AGENDA
FARRAGUT MUNICIPAL PLANNING COMMISSION

January 18, 2018
7:00 p.m. Farragut Town Hall

REPORT TO THE FARRAGUT MUNICIPAL PLANNING COMMISSION

SUBJECT: Discussion and public hearing on a request for approval of a resubdivision plat to remove the Finished Floor Elevation (FFE) and relocate the 50-foot building setback buffer, as measured from the sinkhole lip elevation, for Lot 60 in Unit 3 of the Sheffield Subdivision, .267 Acres, Zoned R-1/OSR (Ryan Lynch, Applicant)

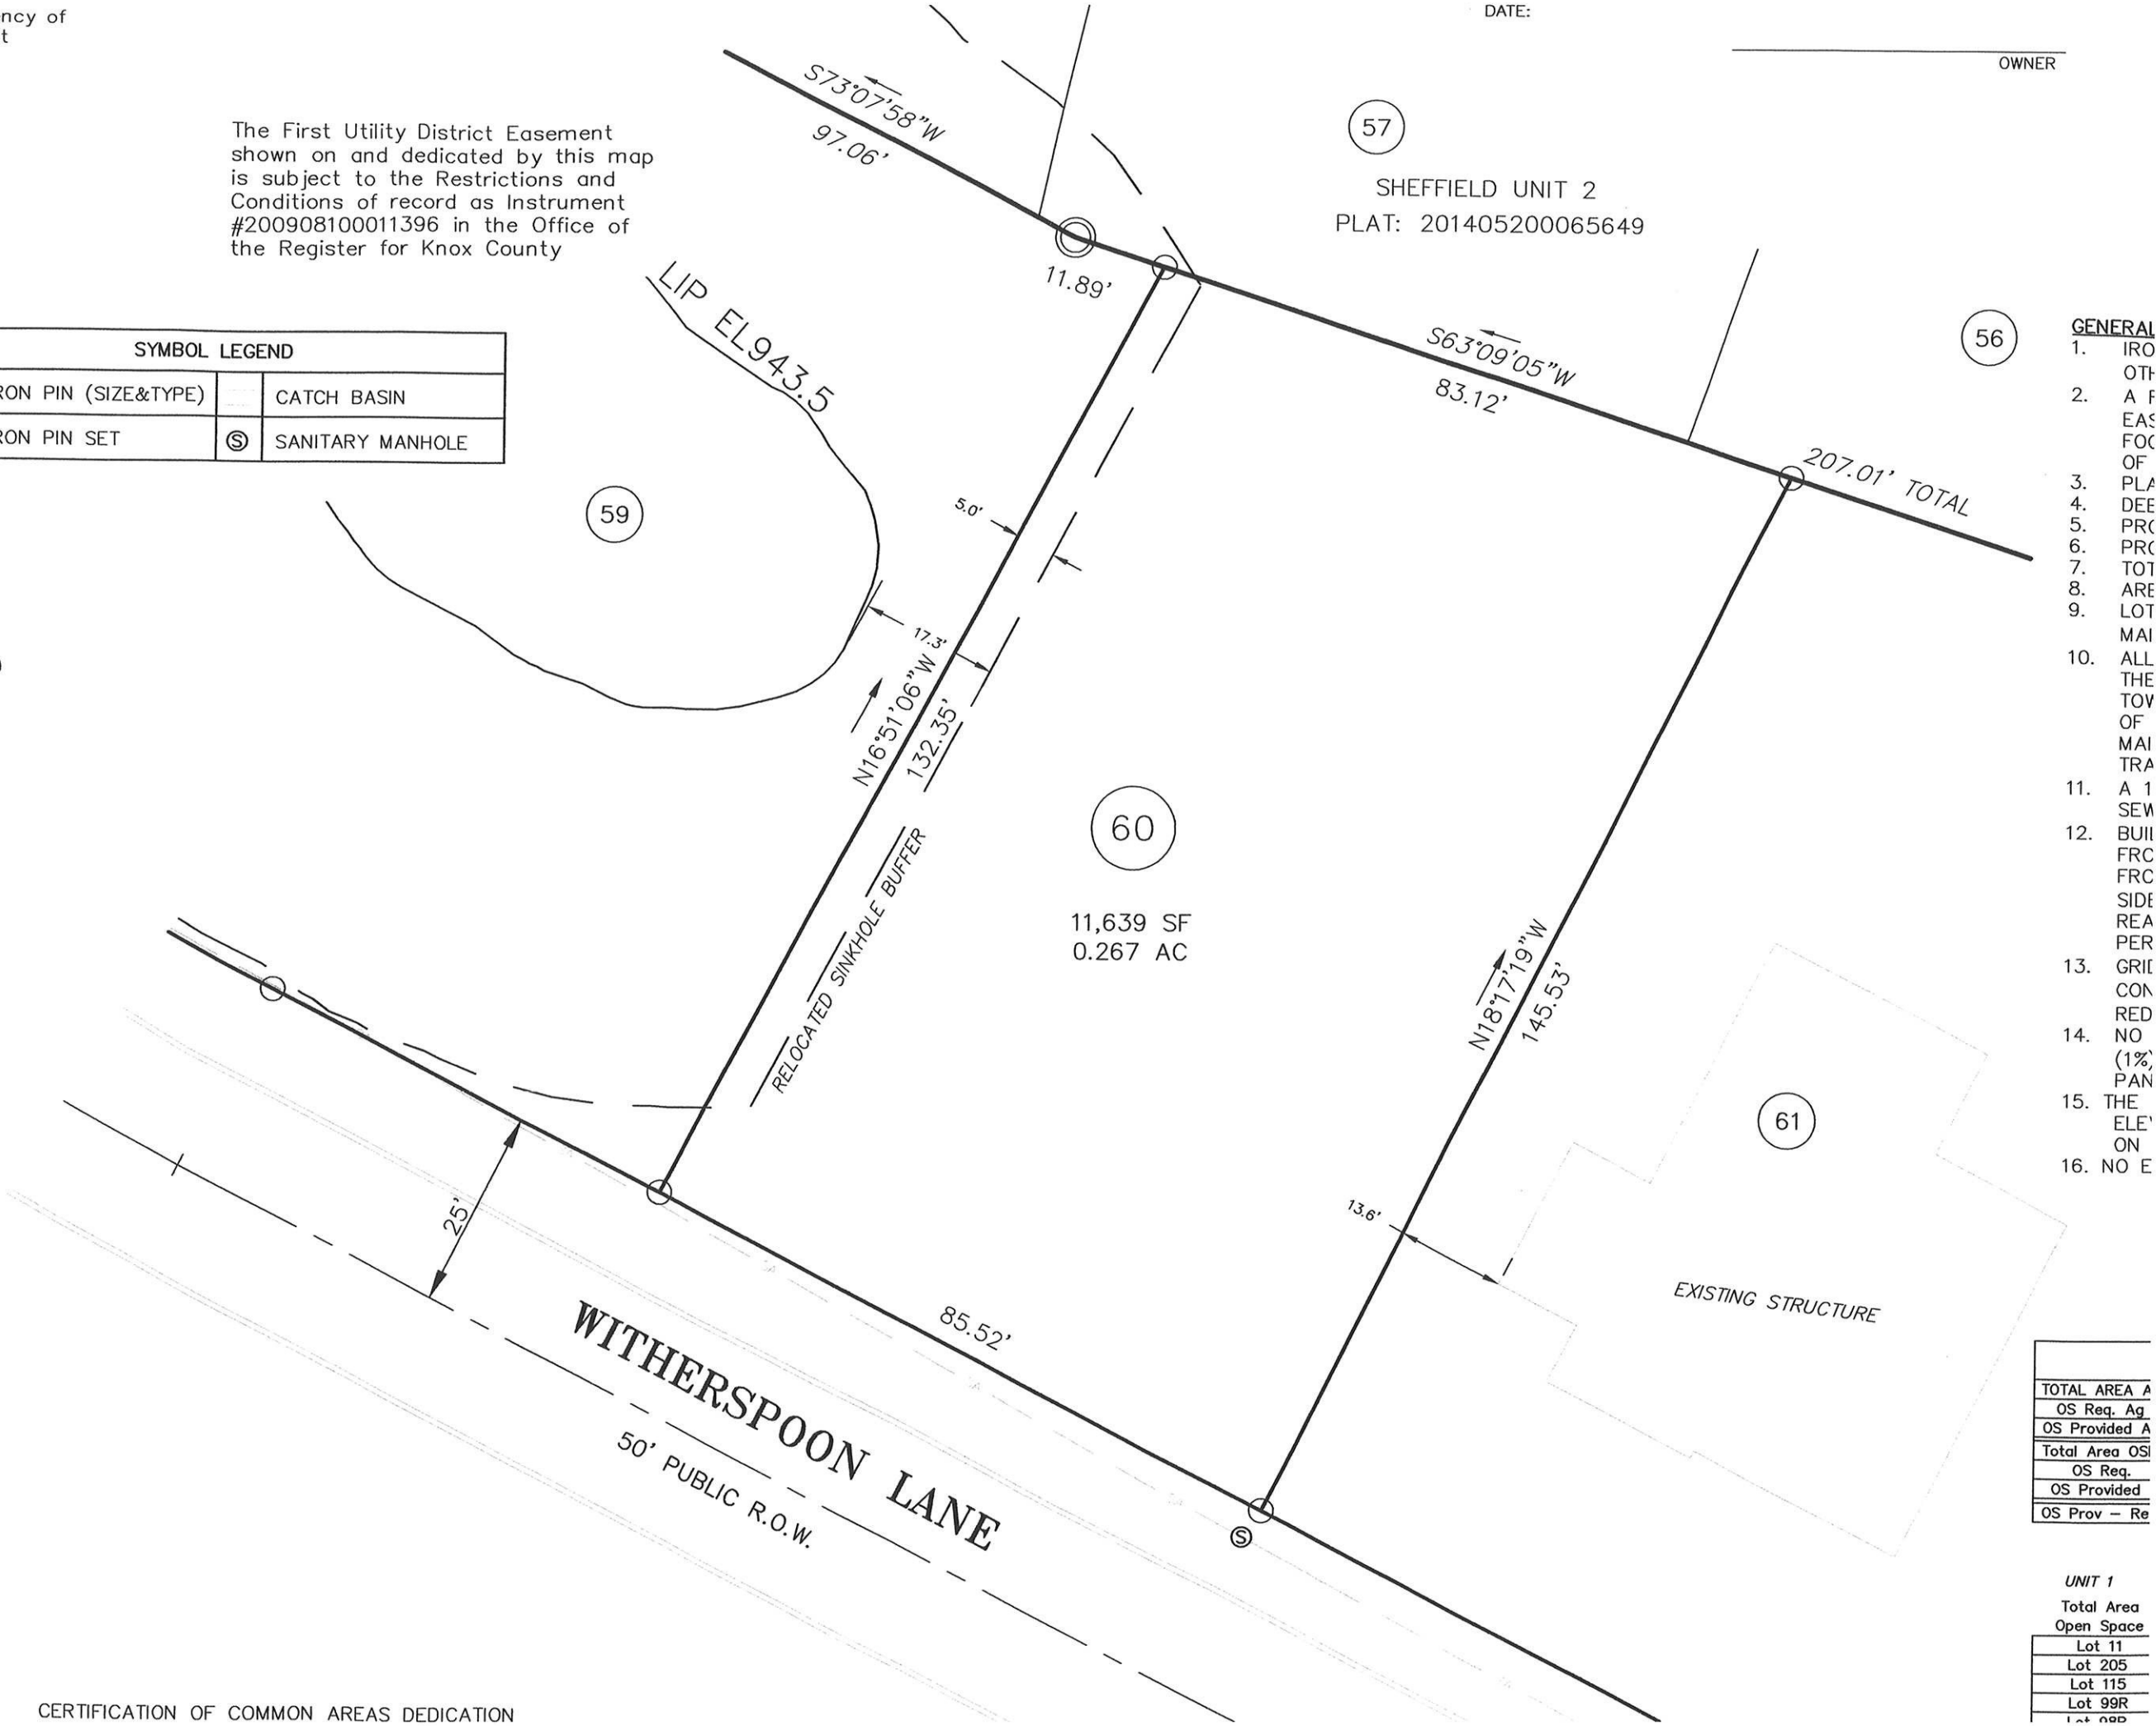
2. Plat Note #15 should be amended to comply with the Minimum Finished Floor Elevation requirement of the recently amended Sinkhole Ordinance. In this case, it would be one (1) foot above the highest adjacent grade measured at the building. This standard applies within 50-feet of a sinkhole where the land in question is not located within a defined sinkhole drainage area. The requirement is not directly related to the building setback line and staff recommends that it be applied to the lot. In addition, any alteration to the F.F.E standard would first require a sperate variance from the provisions of the Sinkhole Ordinance;

3. Plat Note #9 should be amended to clarify that Tax Map "Lot 78" is Lot 59 on both the original plat and this replat;
4. All required certificates should be signed, and the surveyor should sign the face of his stamp.

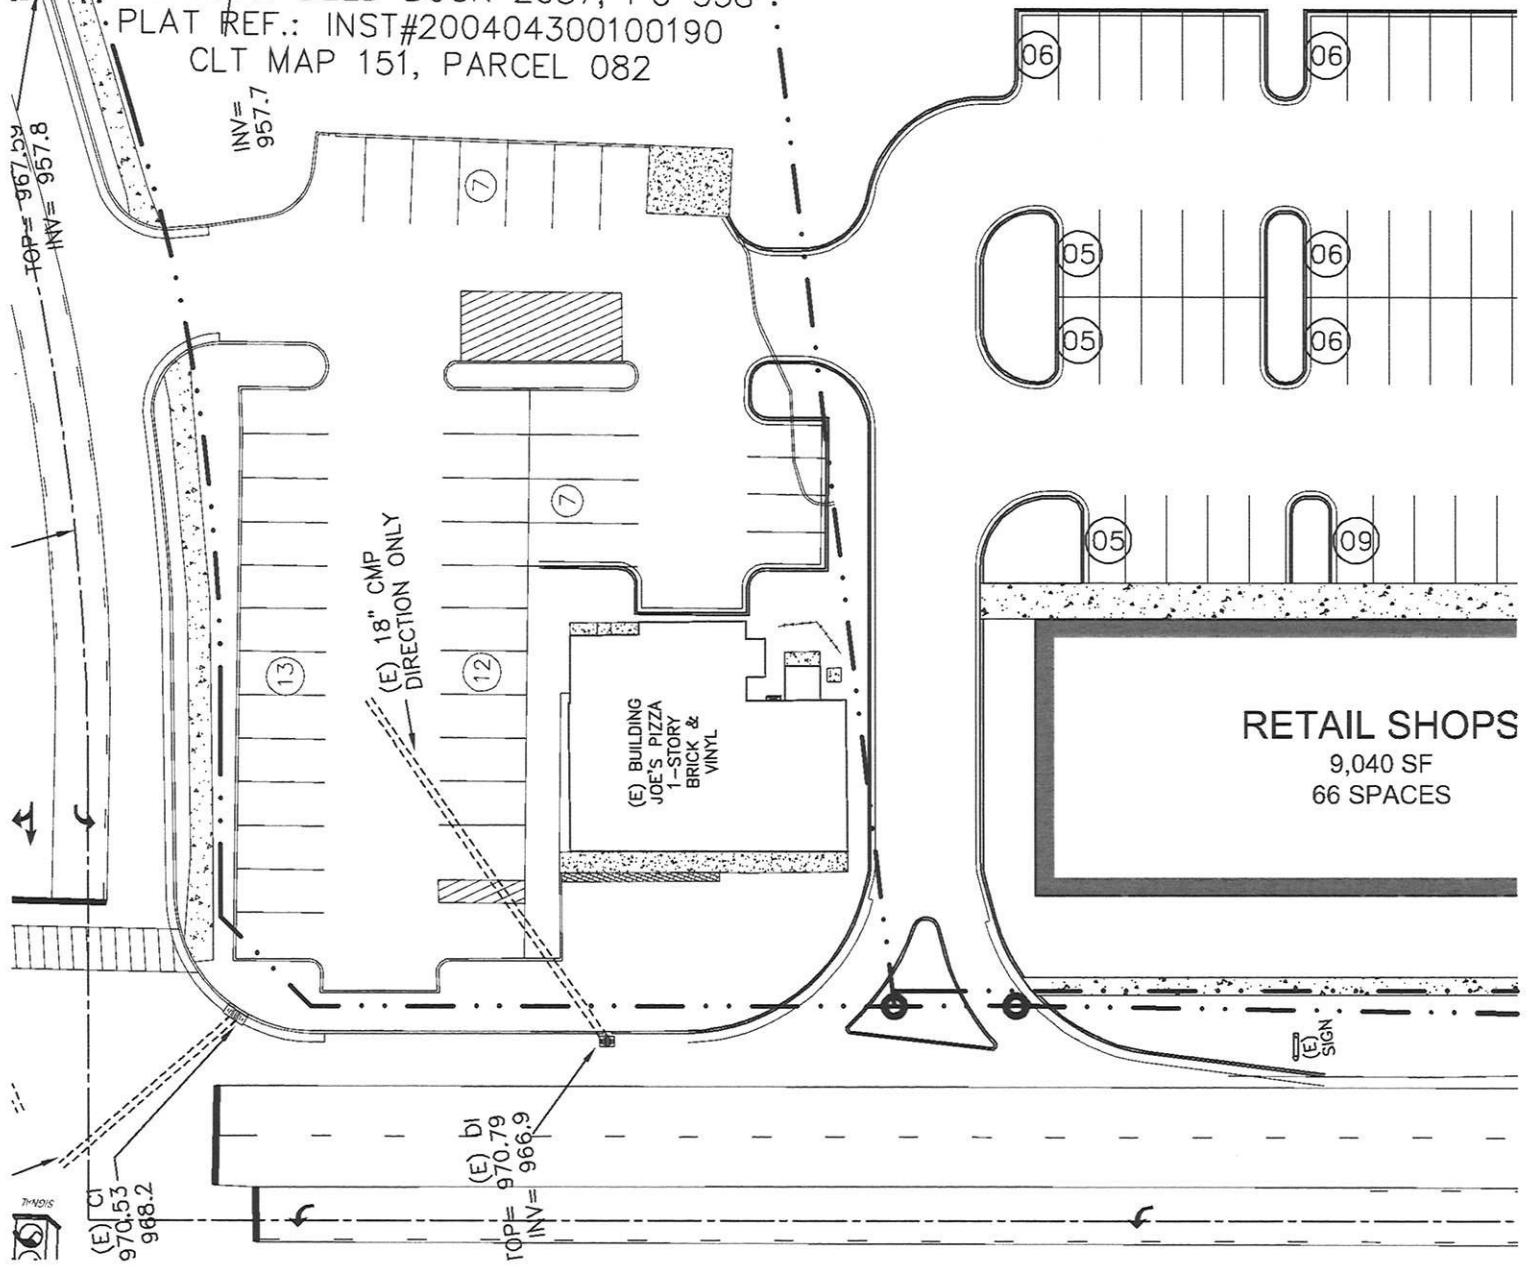
- 1) The Town's planning and engineering staff are concerned with the project's proposed use of an existing access point located approximately 130 feet from the intersection of Kingston Pike and S. Watt Road. This access point currently serves Little Joe's Pizza, via a recorded access easement that is located on the subject property. The site plan, as submitted, includes this access as a second point of ingress/egress along Kingston Pike. The Town's staff is opposed to this access plan and has discussed several design alternatives. These include the following:

- a) The Town's preferred alternative would require the developers to work with the owners of Little Joe's Pizza to close the existing access on Kingston Pike and either combine, or reconfigure both sites to coordinate traffic flow between the sites and route exiting traffic to an access point along S. Watt Road.
- b) A second alternative would involve restricting the existing access point to right-in/right-out traffic only. This would involve a deceleration lane with an exaggerated island to limit improper turning movements. It should also include changes to the internal traffic flow between the proposed development and Little Joe's, to encourage the use of an exit on South Watt Road. This alternative will also require the developers to work with Little Joe's to alter the existing access and coordinate through lot traffic to S. Watt Road.

A traffic study will also be required, in accordance with the Town's ordinances.
